STAFF REPORT 10-11-2023 MEETING

APPLICATION NUMBER: 23-8517

ADDRESS: 20119 WISCONSIN, AKA 8730 CHIPPEWA

SCOPE: REHABILITATE SCHOOL BUILDING, ERECT MULTI-FAMILY BUILDINGS

Proposed rehabilitation of historic building, above. Proposed elevation of new buildings, below.

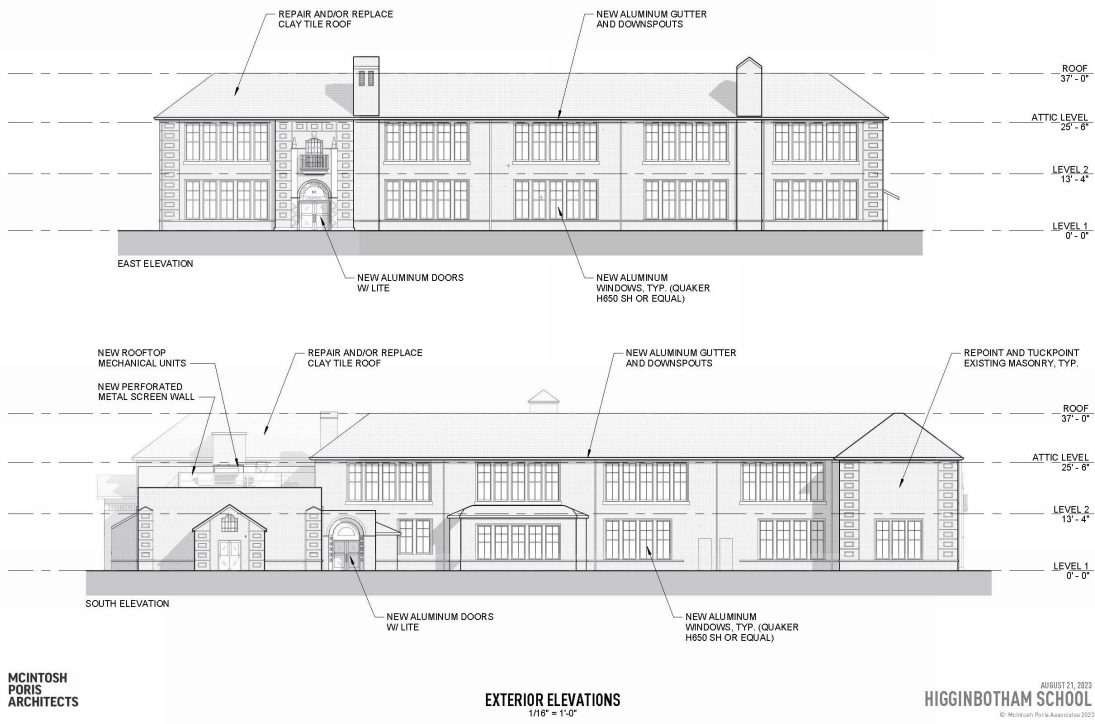
- **HDC Staff Comment:** The proposal is consistent with the height of the original building and represents another addition to the property, of which there are already three.

- **HDC Staff Comment:** The proposal maintains the proportions of the original building as part of the rehabilitation. The proportion of the new buildings are wider than tall, consistent with the historic prototype.

- **HDC Staff Comment:** The proposal seeks to replace the remaining historic windows/doors in the original building while maintaining the historic openings. The new buildings have compatible regular window openings. Additional discussion of the windows and doors is provided below.

- **HDC Staff Comment:** The solids to voids rhythm in the original building is preserved by the proposed rehabilitation; the new buildings have a compatible rhythm which does not compete with, and respects, the complexity and primacy of the historic building.

- **HDC Staff Comment:** The proposal preserves historic entrance features while sympathetically introducing new aluminum doors. The entrances for the new buildings occur in several locations and are conceptually consistent with the prototypes on the historic building in terms of recess and projection.

- **HDC Staff Comment:** The proposal preserves and restores historic material. The distinctive clay-tile roofing, according to the applicant, will be repaired or replaced with new clay tile. The new building incorporates modern materials, and modern analogs of the historic materials, which is appropriate under the Standards.

- **HDC Staff Comment:** The proposal preserves and restores historic textures on the original building. The new building uses several textures, including brick at the base and ribbed metal panel, to create textural interest and shadow lines befitting its contemporary design.

- **HDC Staff Comment:** The proposal preserves and restores historic colors on the original building. The colors on the new construction are directly imported from those on the historic prototype.

- **HDC Staff Comment:** Preservation and rehabilitation of the original building will retain the architectural details mentioned in the Elements of Design. The new building, built in a contemporary style, exhibits a similar pattern of detailing at several different scales, but with an appropriately modern vocabulary.

- **HDC Staff Comment:** The proposal preserves or replaces historic roofing materials in-kind, and preserves the roof geometry of the original building. The new building is flat-roofed and deferential to the historic context. Staff assesses that recreating a pitched or tiled roof on the new buildings will substantially detract from the primacy of the historic core building.

- **HDC Staff Comment:** Important historic detail and elements on the historic building will be preserved and perpetuated in the proposed rehabilitation. The proposed new windows are appropriately subdivided to match the historic prototypes. The new construction, through the choice of windows, façade materials, and design elements appropriate to its modern character, also incorporates scalar range.
